Project Name: Hilton Garden InnMaster File: #13-0089

Date: Nov. 14, 2013

CITY OF OLYMPIA
BASIC COMMERCIAL DESIGN CRITERIA
Chapter 18.110

**Olympia Hilton Garden Inn
Design Review Narrative
Response to Olympia Municipal Design Criteria Chapters 18.110 and 18.145**

GUEST ROOM WINDOW SECTION

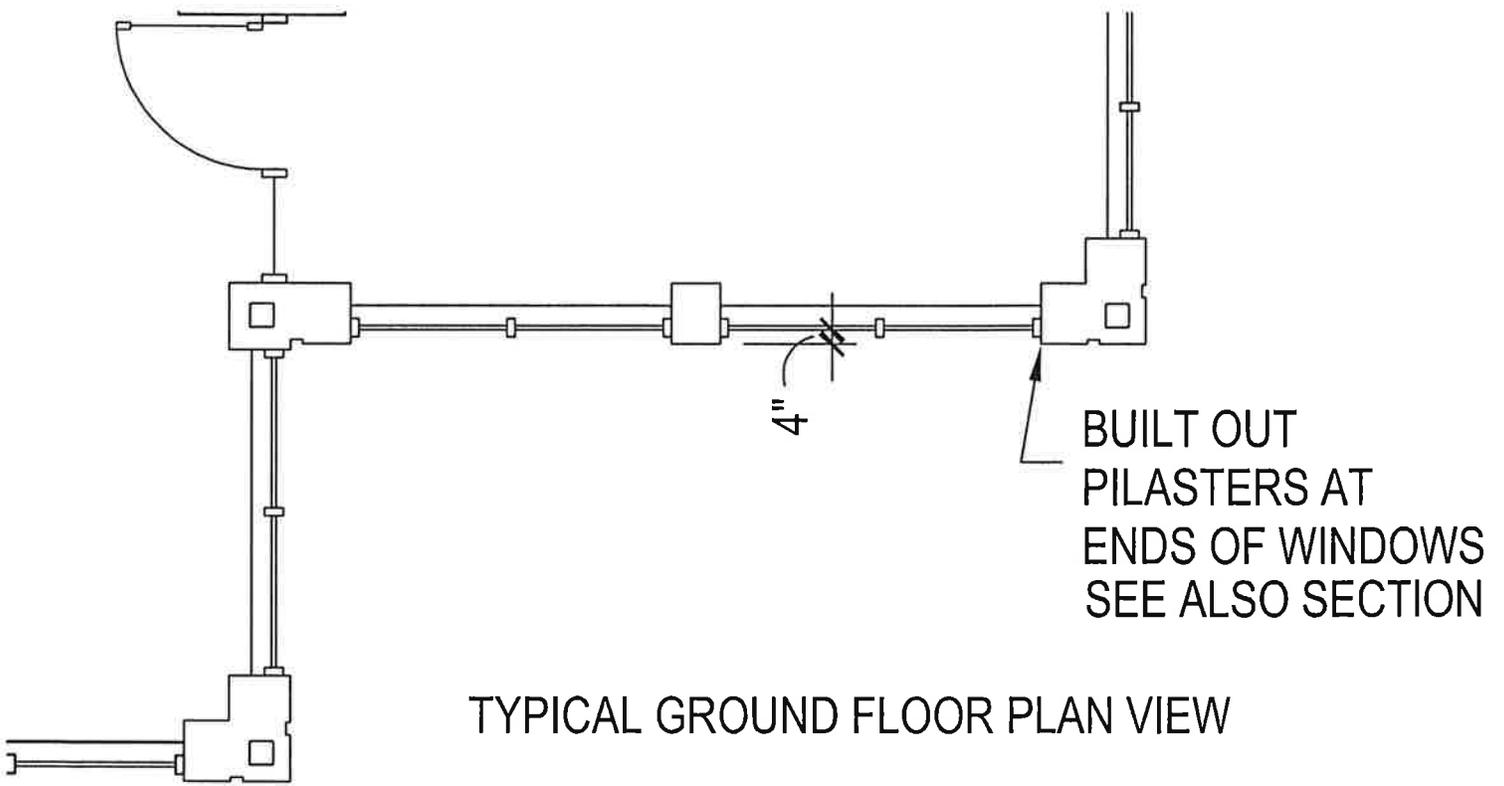
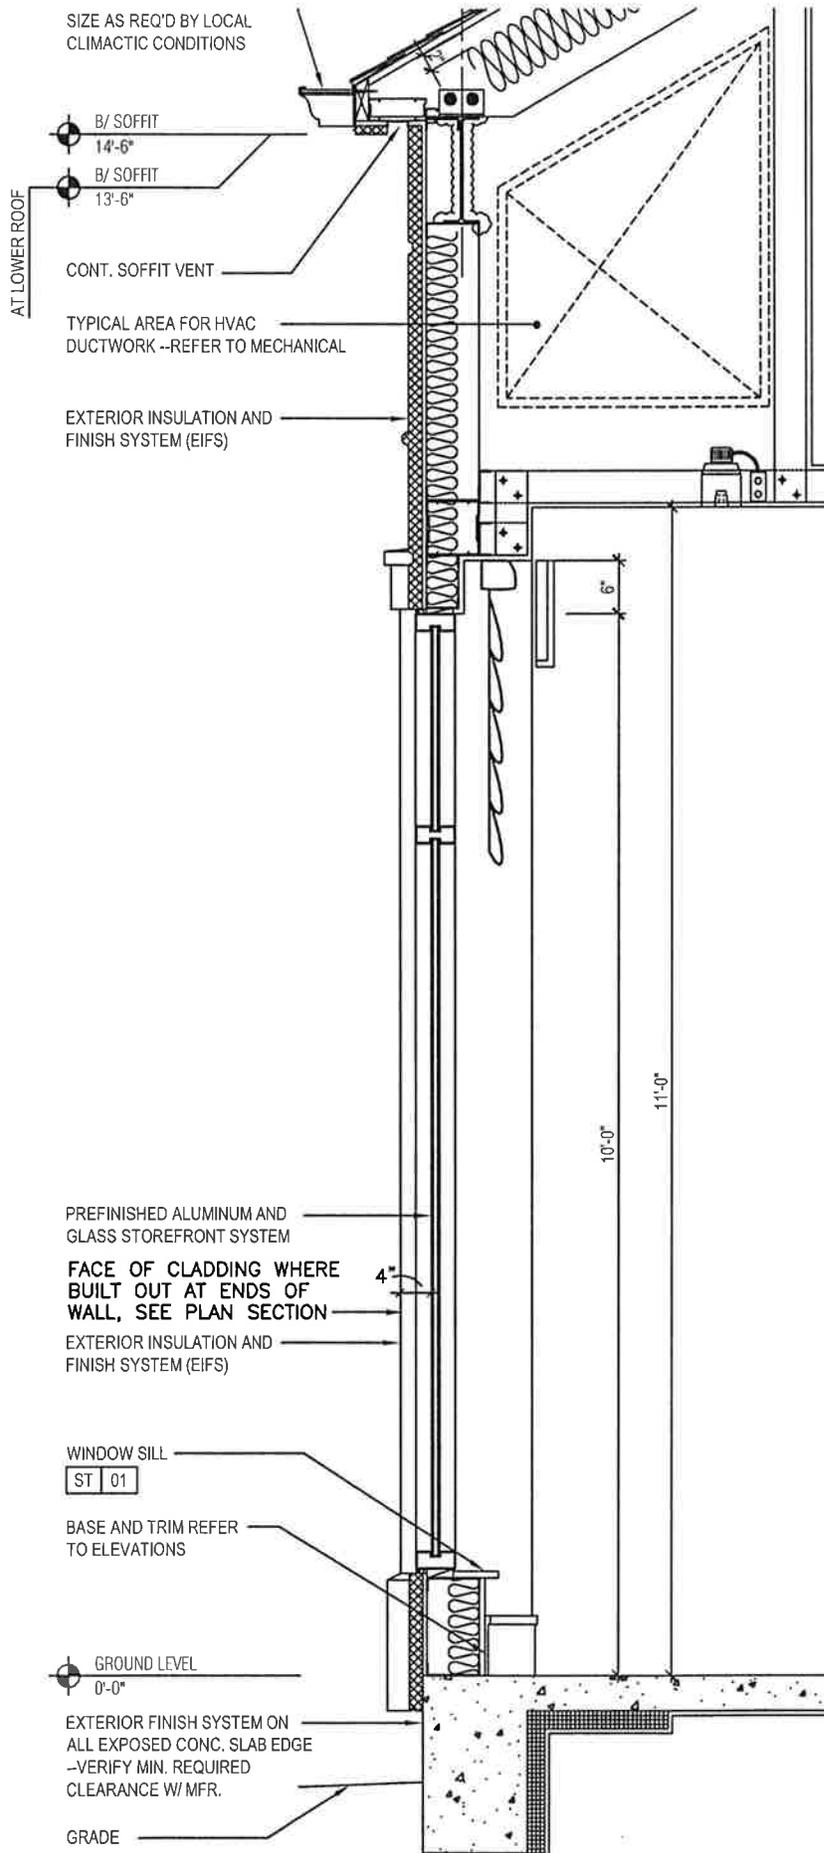
Windows on the hotel tower are recessed 6 ½ inches to the reveal, and 8 inches to the overall cladding (see detail in plan set). Staff recommends that additional elements be added such as lintels, sills, casings, and mullions. This has been included as a condition of approval in the staff report.

NORTH WEST ELEVATION
1/8" = 1'-0"

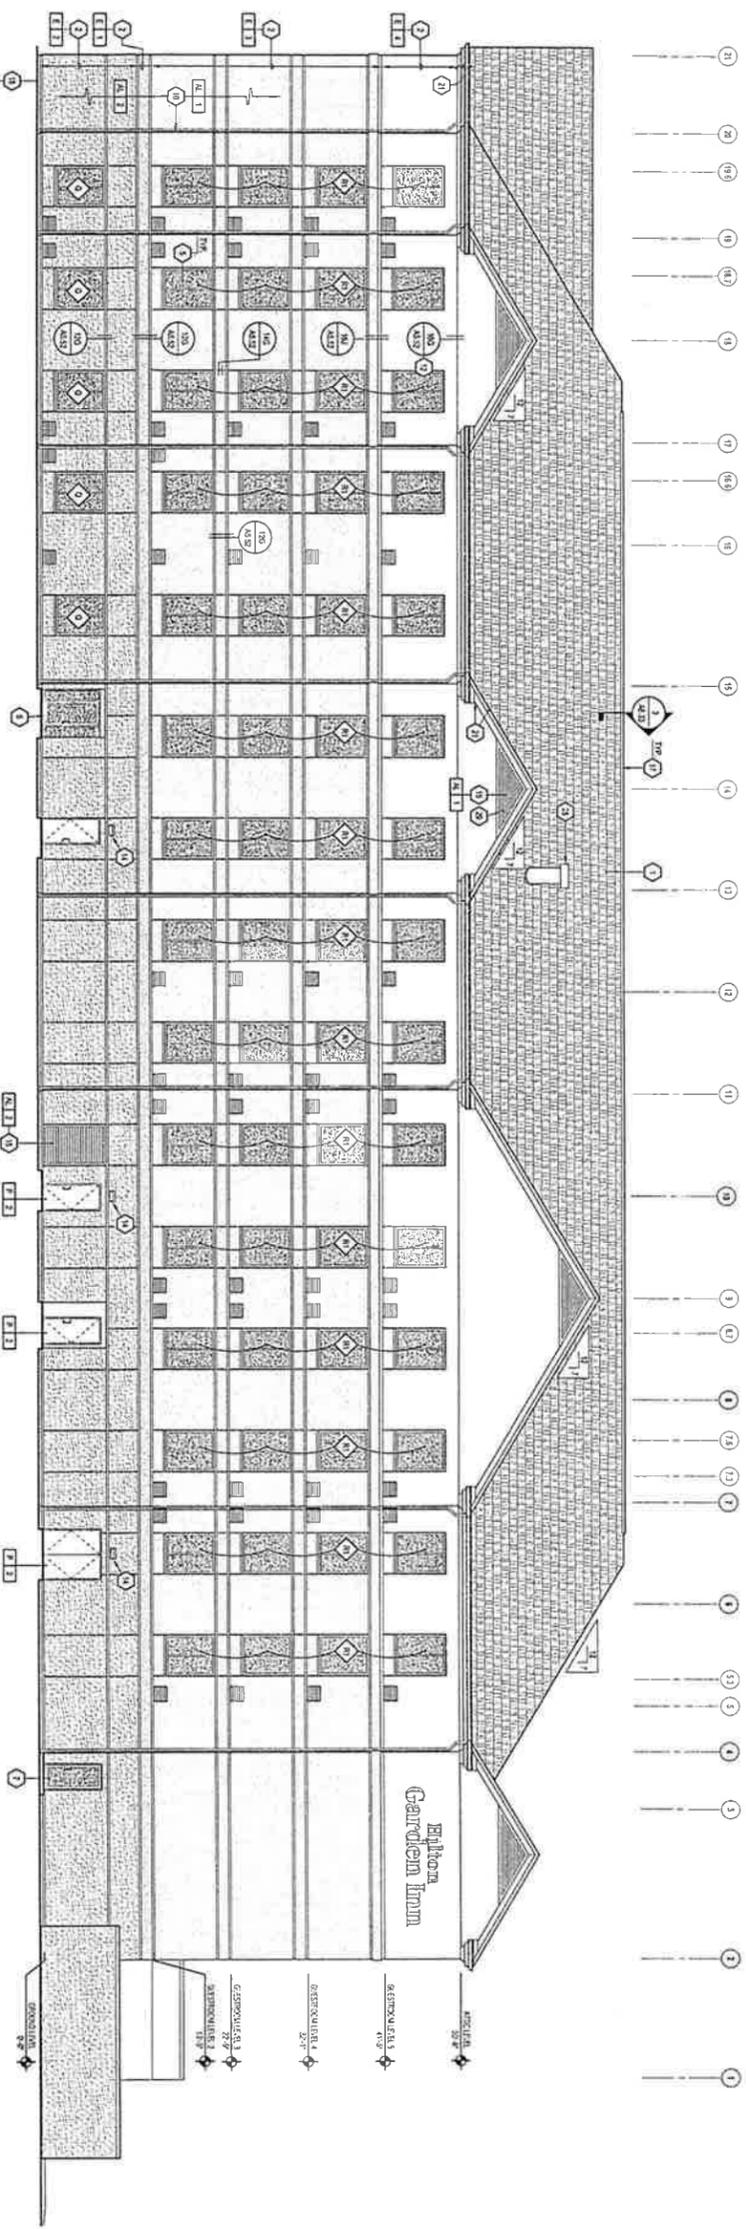
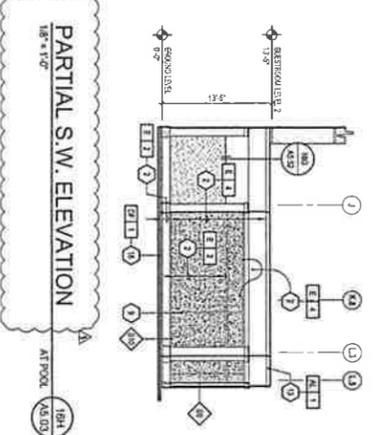
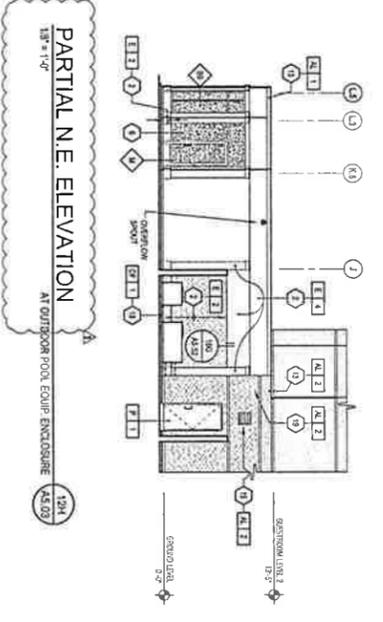
The building provides a consistent level of materials, colors and detailing on the southeast and northwest elevations but less so on the northeast and southwest elevations, which are also visible to the general public. Staff recommends that additional windows and architectural detailing be added to these elevations to provide greater detailing, and establish greater consistency on all four sides of the building. This has been included as a condition of approval in the staff report.

STAFF RESPONSE: *As noted above, the northeast, south end of the northwest, and southwest elevations contain little detailing. The shallow depth of planting beds makes it difficult to plant screening vegetation, so other approaches will be required such as additional windows, change of materials, and other architectural detailing. This has been included as a condition of approval in the staff report.*

1 ELECTRICAL SITE PLAN
 SCALE: 1"=30'-0"

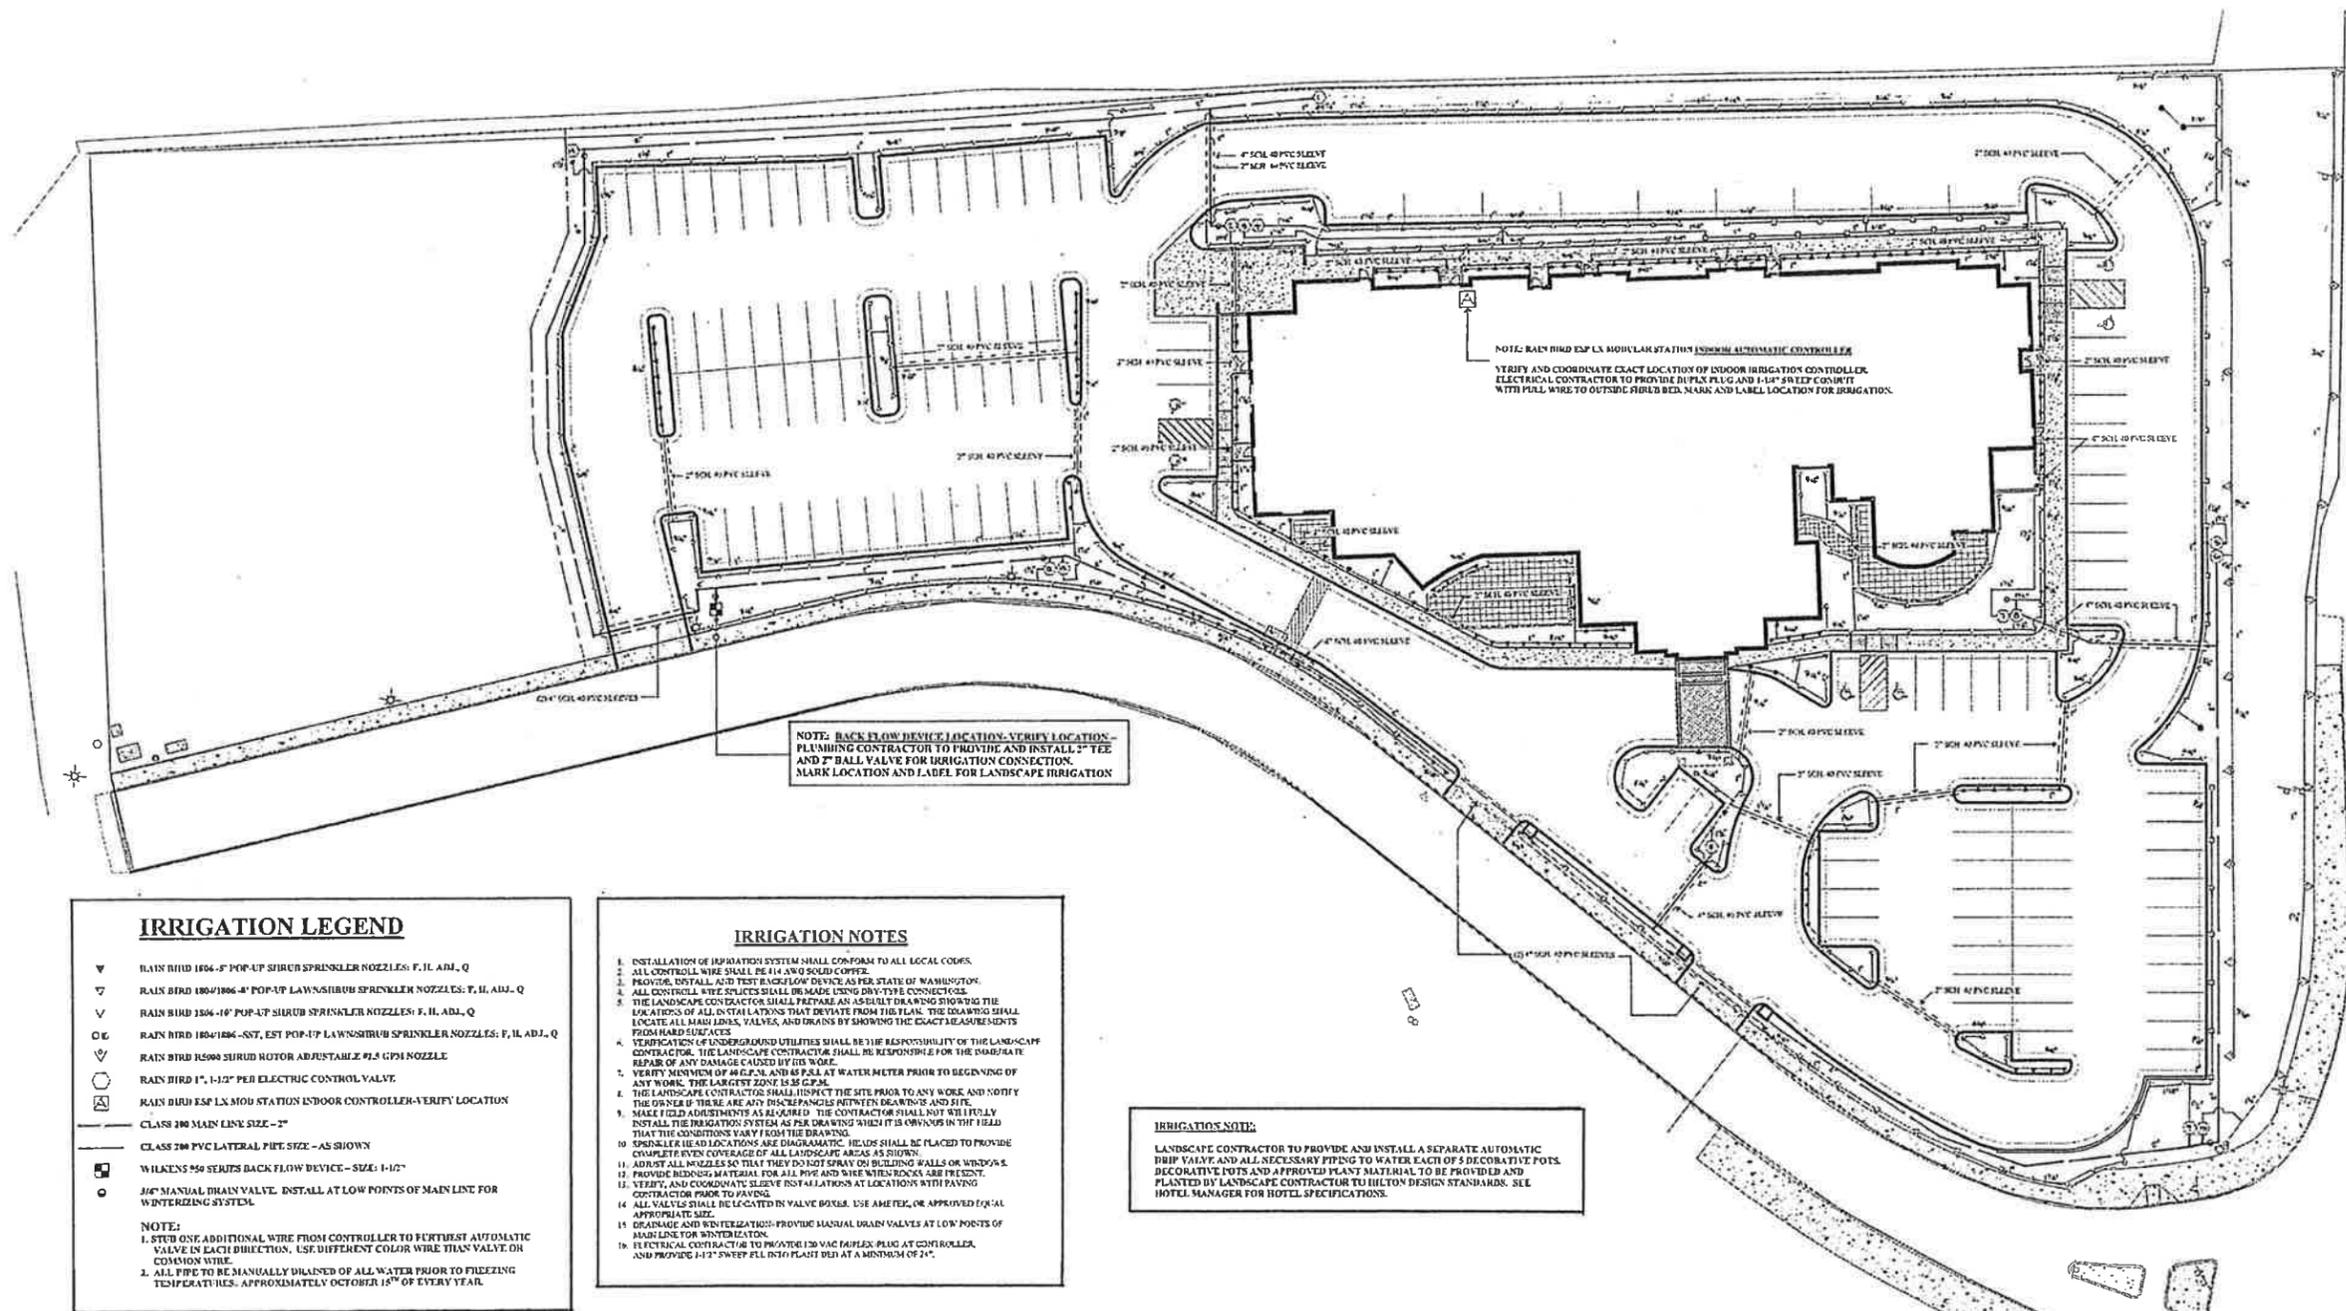
At this stage of review, only pole lighting in the parking lot and lighting over ingress/egress doors is proposed. To better comply with this requirement, staff recommends that additional lighting be added, in particular along walkways and drive aisle crossings for pedestrian safety. This has been added as a condition of approval in the staff report.

Pole lights are proposed along the northwest perimeter of the site; the applicant’s design narrative indicates that cutoff fixtures will be used. Cut sheets are typically provided at the time of Detail Design Review.
